UNITED STATES PATENT AND TRADEMARK OFFICE

APPLICATION NO.	FILING DATE	FIRST NAMED INVENTOR	ATTORNEY DOCKET NO.	CONFIRMATION NO.
10/604,703	08/11/2003	David Elder	WT-001	1702

Office Action Summary	Application No. 10/604,703	Applicant(s) ELDER ET AL.	
	Examiner Pia F. Tibbits	Art Unit 2838

DETAILED ACTION

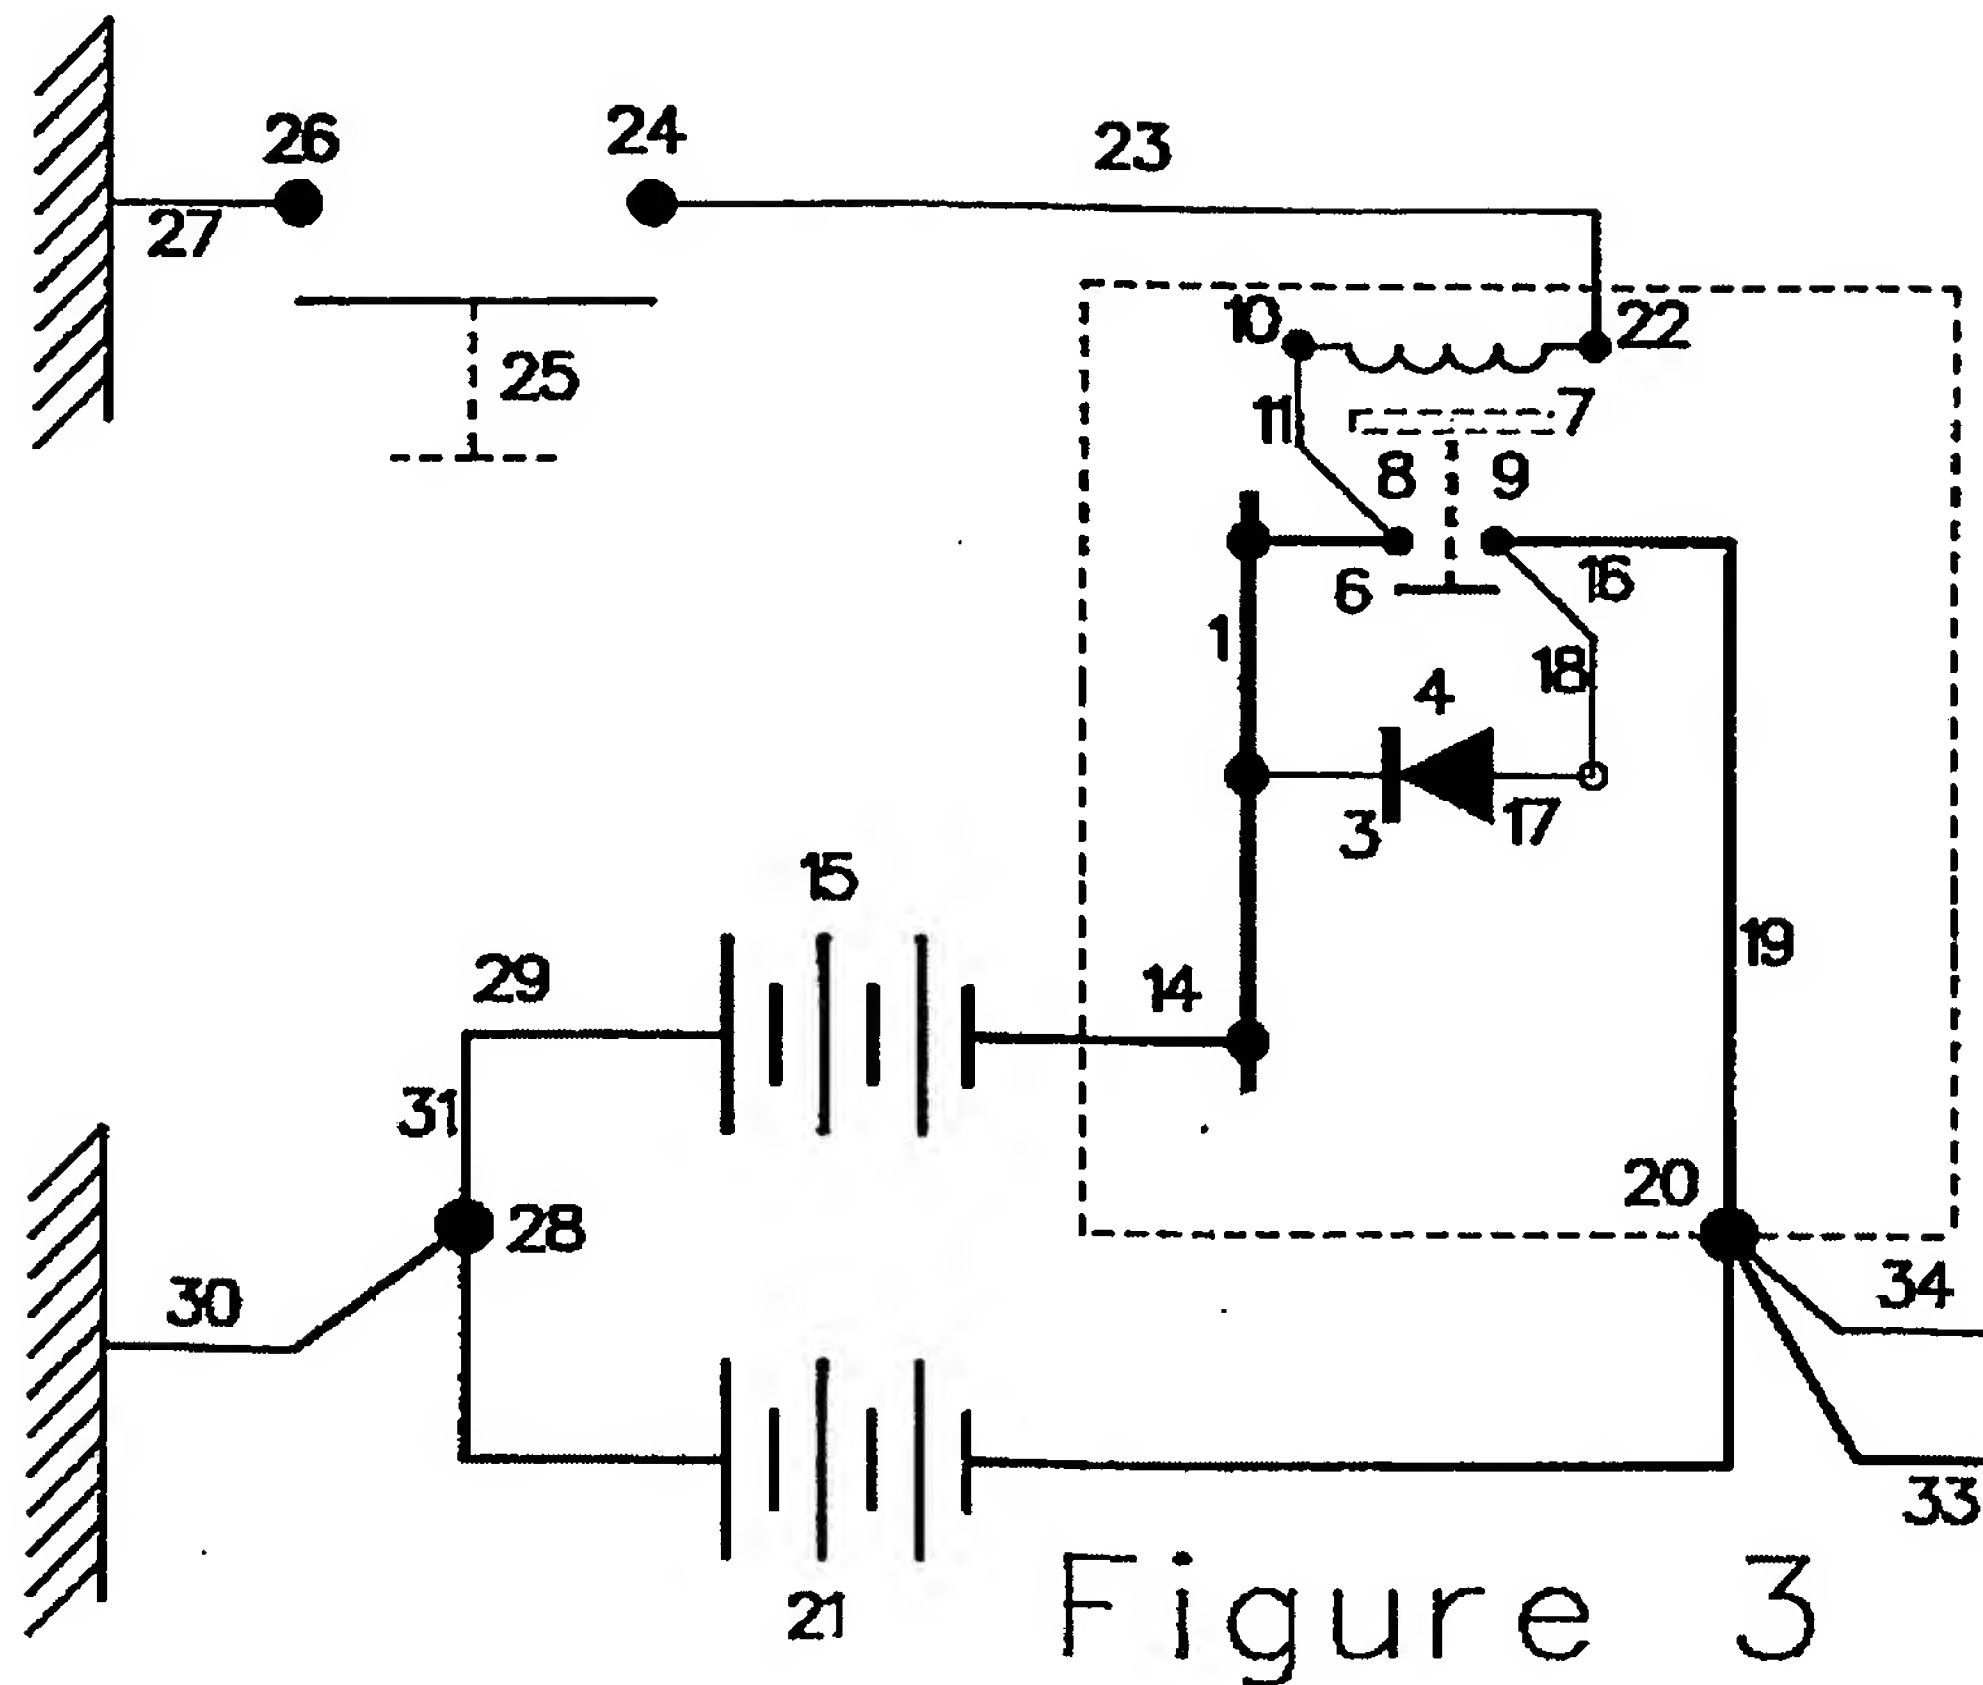
3. Claims 88, 95, 104, 105 are rejected under 35 U.S.C. 102(b) as being anticipated by **GB-2220112** [hereinafter GB].

GB discloses in figures 1-3 an apparatus for reliably supplying electrical energy to an electrical system connected between a system positive terminal and a system negative terminal, the apparatus comprising:

a switching device [see fig.3] operable in two operating positions to at least selectively electrically connect the system positive terminal to one of the main positive output and the at least one standby positive output, the switching device being operable in a first operating position/"push the switch back to the main battery/unit" to electrically connect the main positive output to the system positive terminal and electrically disconnect the system positive terminal from the at least one standby positive output, the switching device being further operable in a second operating position/"push switch to the live reserve unit" independent of the first operating position to electrically connect the at least one standby positive output to the system positive terminal and electrically disconnect the system positive terminal from the main positive output, wherein, when the switching device is in the first operating position, the main battery is the sole source of electrical energy to the electrical system and wherein when the switching device is in the second operating position, the at least one standby battery is the sole source of electrical energy to the electrical system, such that the main battery and the at least one standby battery never supply electrical energy to the electrical system simultaneously [see fig.3; page 5].

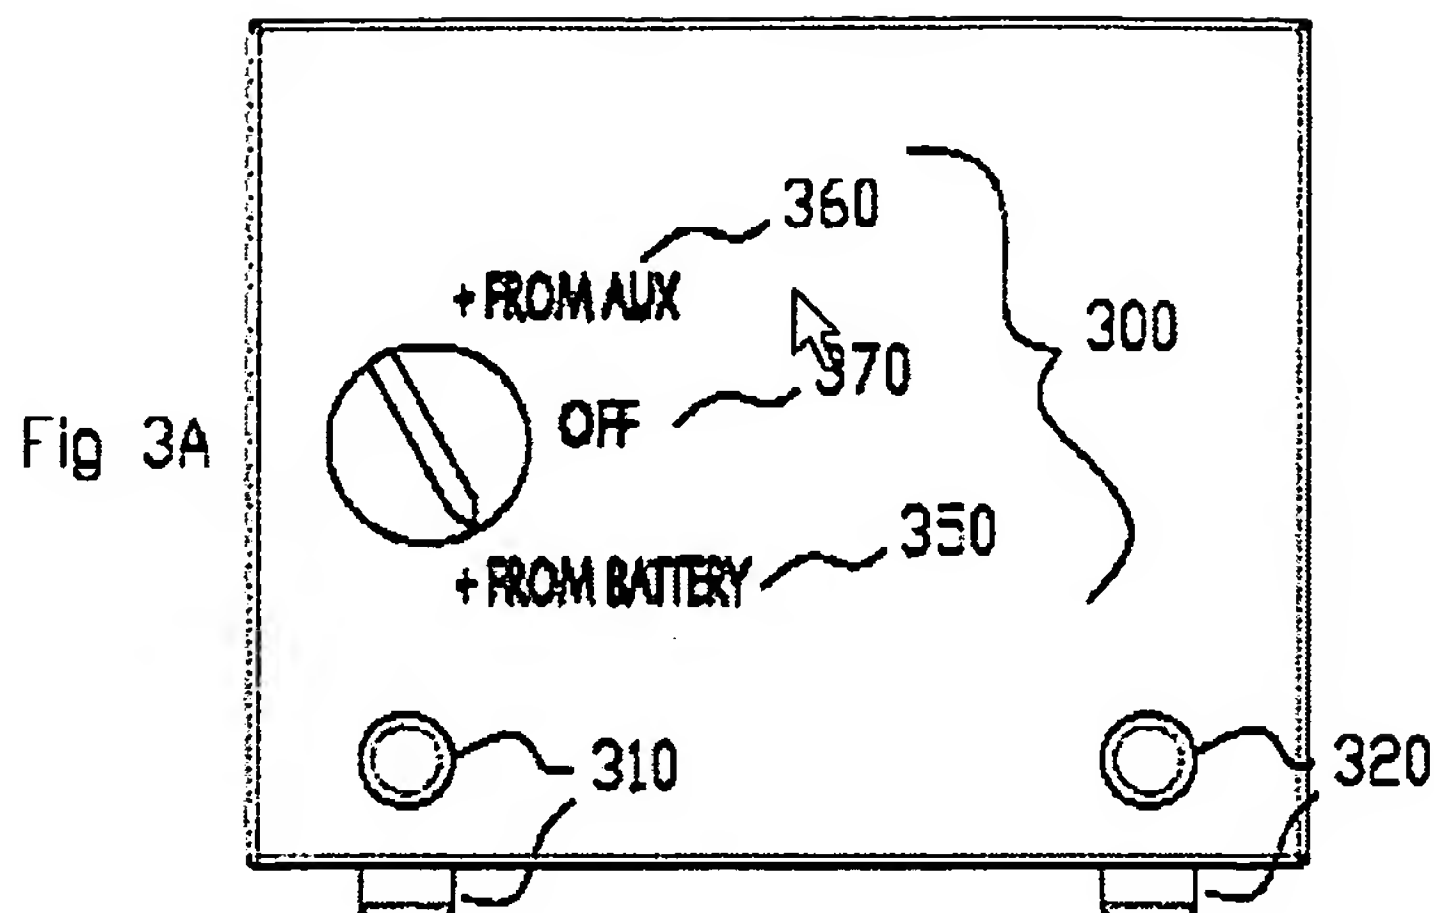
Cook discloses a multiple battery system for a vehicle comprises a primary battery; a reserve battery electrically connectable to the primary battery; and a control unit with a relay switch electrically connected between the primary and reserve batteries. The relay switch is operable on a timer

circuit 140 selected to create a predetermined time period during which the relay switch 120 remains closed. After the predetermined time period, the relay switch 120 returns to the normally open position to switch the reserve battery 14 out of the vehicle's electrical circuitry. In this manner, further discharge of the reserve battery is prevented. This feature is especially advantageous over the prior art relay switches that must be manually switched from an open position to a closed position prior to cranking the engine and switched again to the open position after the engine starts, since it is no longer necessary for the user to remember if the relay switch has been returned to the open position. In this manner, the reserve battery 14 is not subject to the same charge and discharge conditions of the primary battery 12, and therefore will be ready for use when the primary battery is insufficient for starting the motor and/or operating vehicle accessories [see column 6, lines 19-35]. Therefore, it would have been obvious to a person having ordinary skill in the art at the time the invention was made to modify Exide Switch Technology's and Prior Art's apparatus and include a timer controlling charge and discharge/cycling conditions of the standby/reserve battery, as disclosed by Cook, in order to prevent subjecting the standby/reserve battery to the same charge and discharge conditions of the main/primary battery, and therefore be ready for use when the primary battery is insufficient for starting the motor and/or operating vehicle accessories.

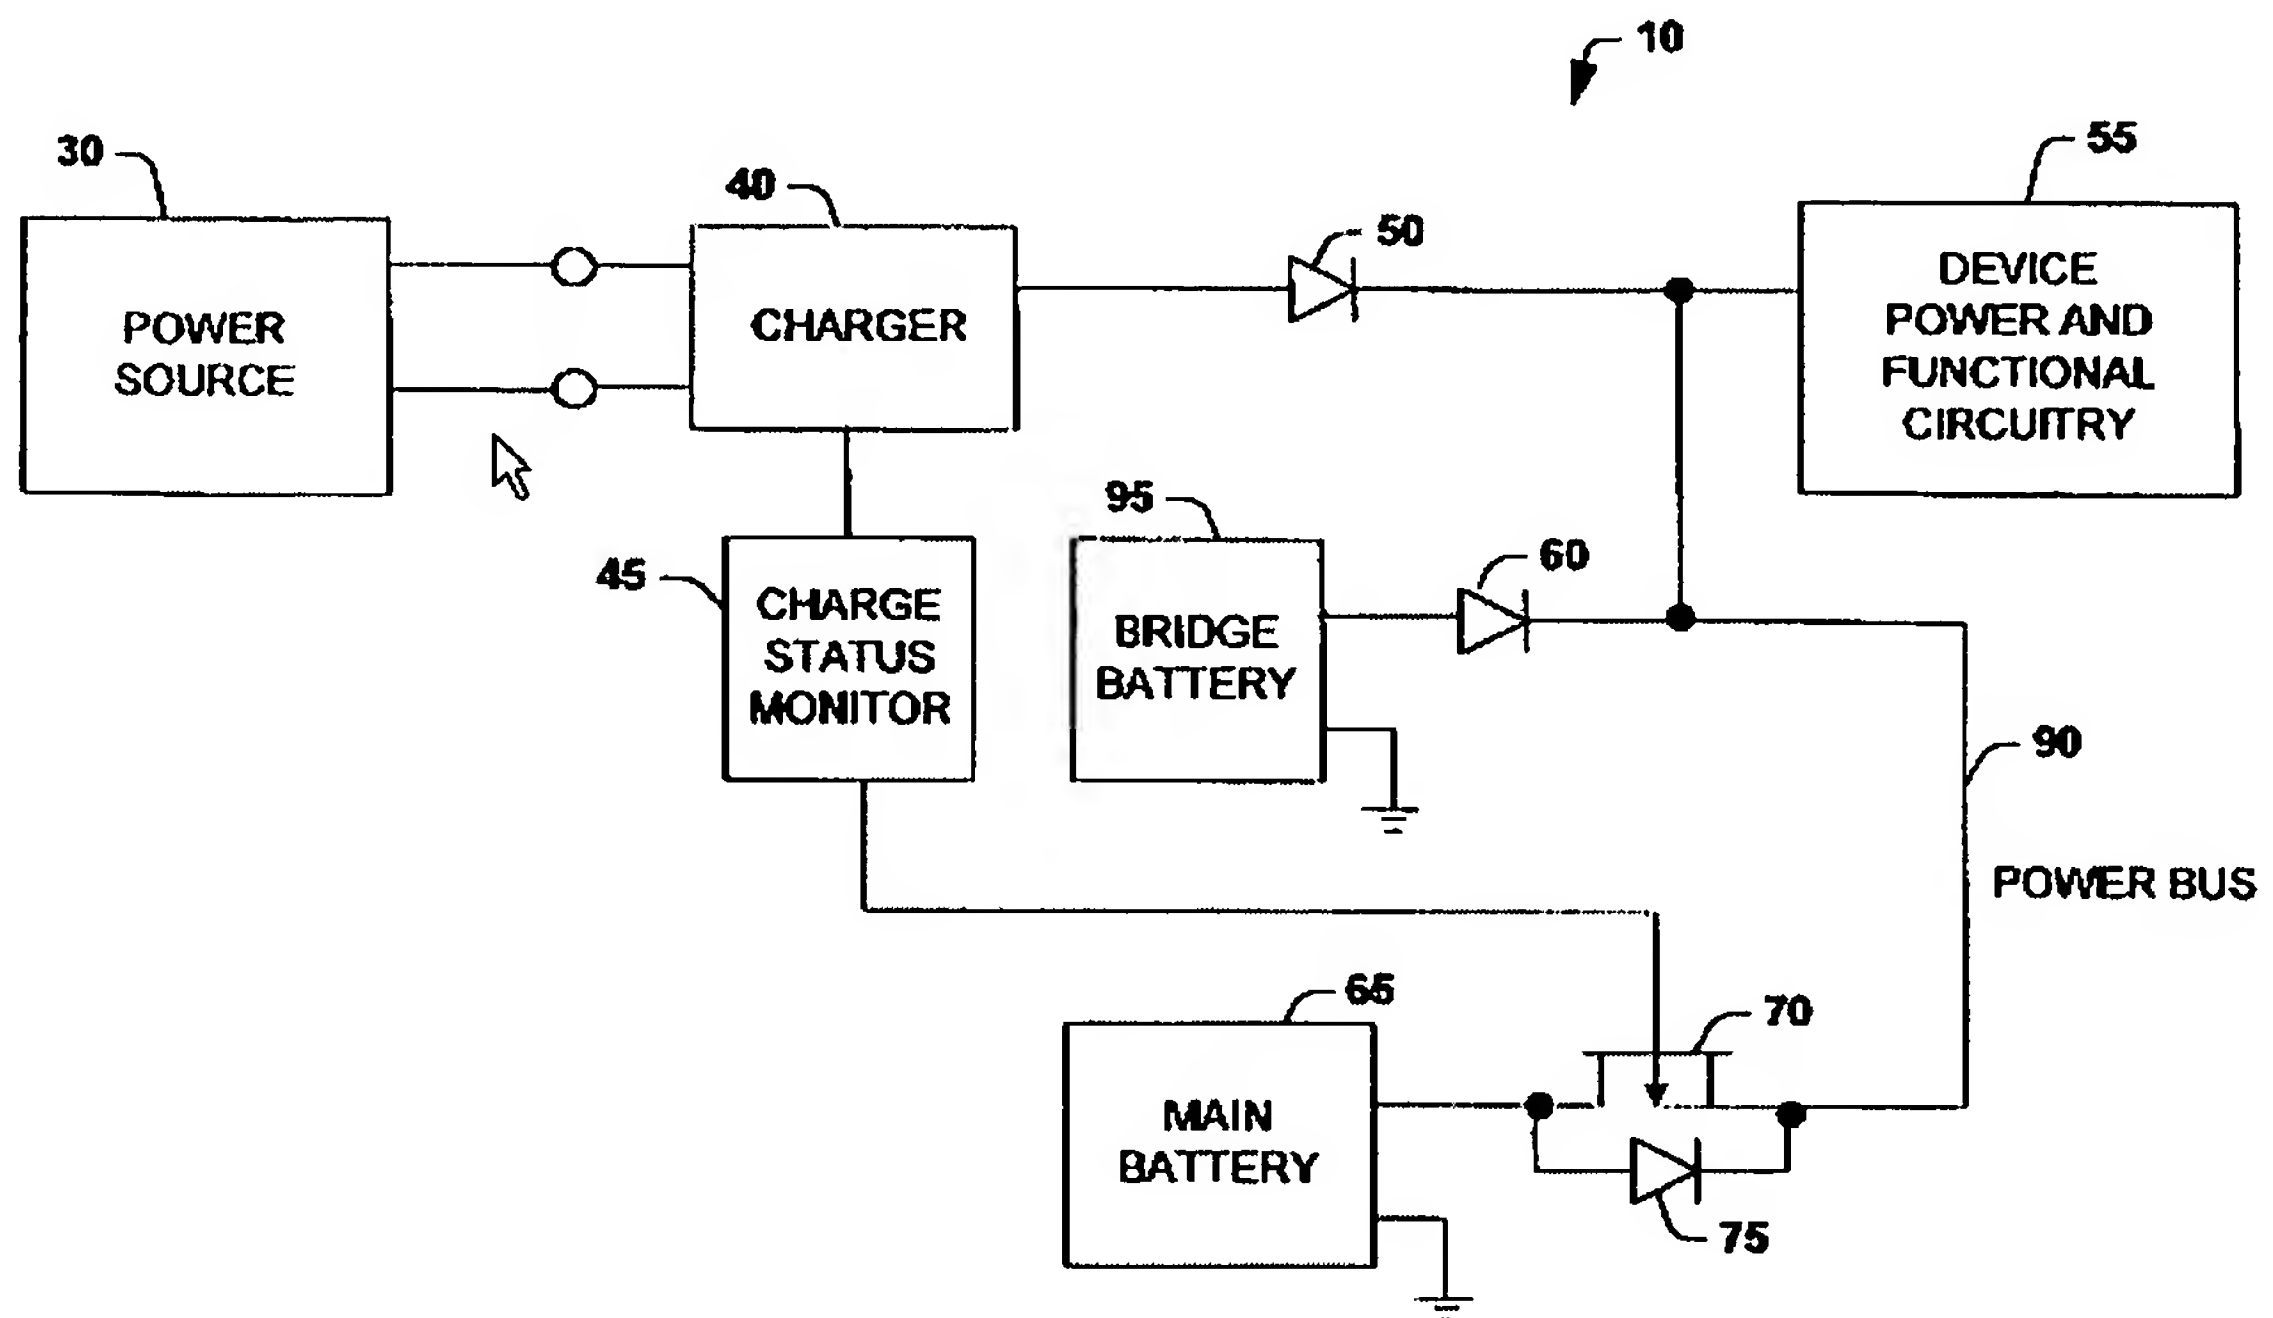
10. Claims 88, 95, 104, 105 are rejected under 35 U.S.C. 102(b) as being anticipated by **Leppo et al.** [6172478][hereinafter Leppo].

Leppo discloses in figures 1-6 an apparatus for reliably supplying electrical energy to an electrical system connected between a system positive terminal and a system negative terminal, the apparatus comprising:
